Item Name: Strut Assembly

APICAL INDUSTRIES, INC.
dba DART AEROSPACE

ENGINEERING CHANGE NOTICE NO.

DWG TITLE: STRUT ASSY

DWG NO. 647.7700

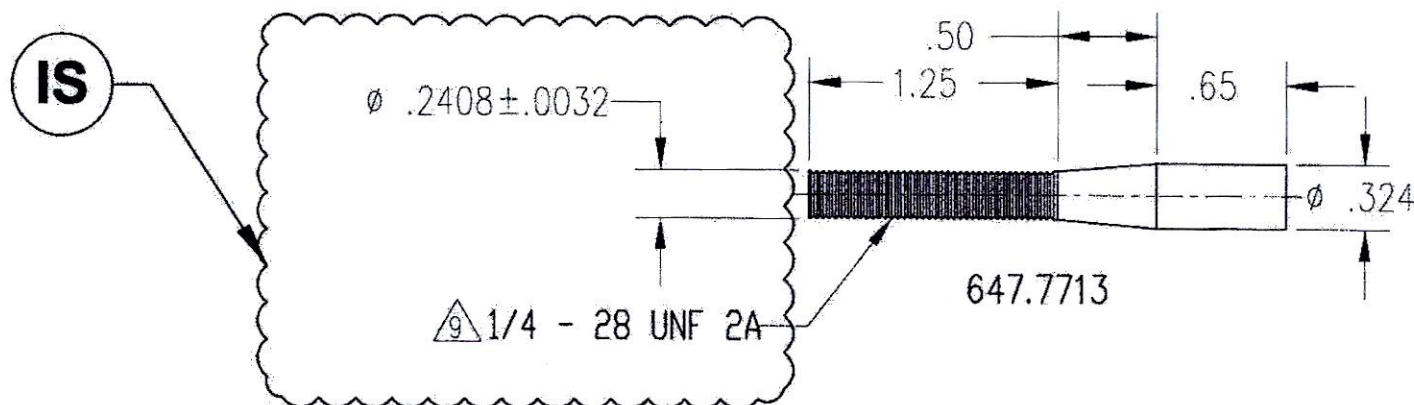
REASON: REVISED DIMENSION

SHEET 2, ZONE D4 IS:

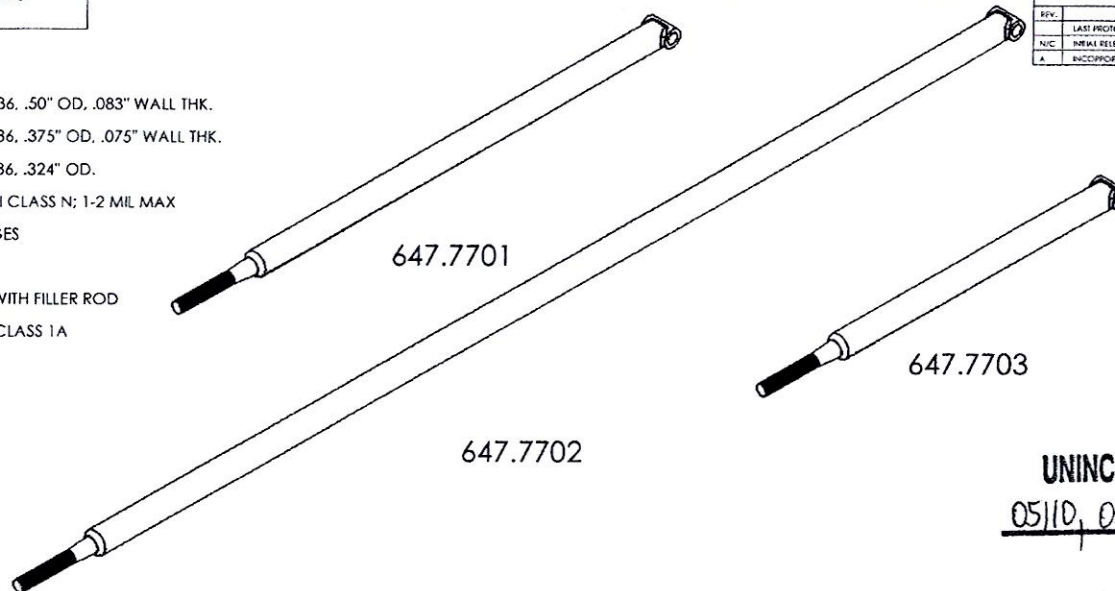
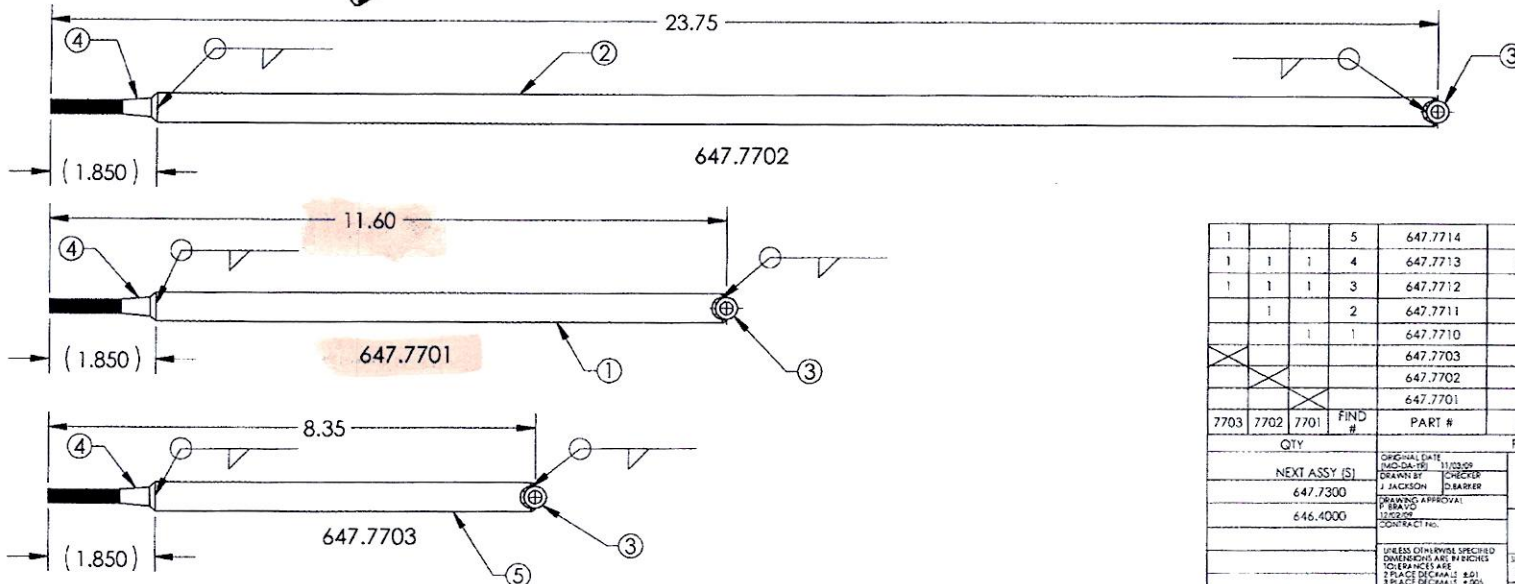
REASON: REVISED FINISH CALLOUT AS PER ECR 15-209

SHEET 1, NOTES IS:

- 1 MATERIAL: 4130 STEEL PER AMS-T-6736, .50" OD, .083" WALL THK.
- 2 MATERIAL: 4130 STEEL PER AMS-T-6736, .375" OD, .075" WALL THK.
- 3 MATERIAL: 4130 STEEL PER AMS-T-6736, .324" OD.
- 4 FINISH: PRIME IAW MIL-P-2337J TYPE I CLASS N; 1-2 MIL MAX
5. DEBURR AND BREAK ALL SHARP EDGES
6. IDENTIFY IAW MPP-120.
- 7 WELD IAW MIL-STD-2219. TIG WELD WITH FILLER ROD
- 8 FINISH: CAD PLATE IAW QQ-P-416F CLASS I TYPE II
- 9 MASK THREAD PRIOR TO FINISH
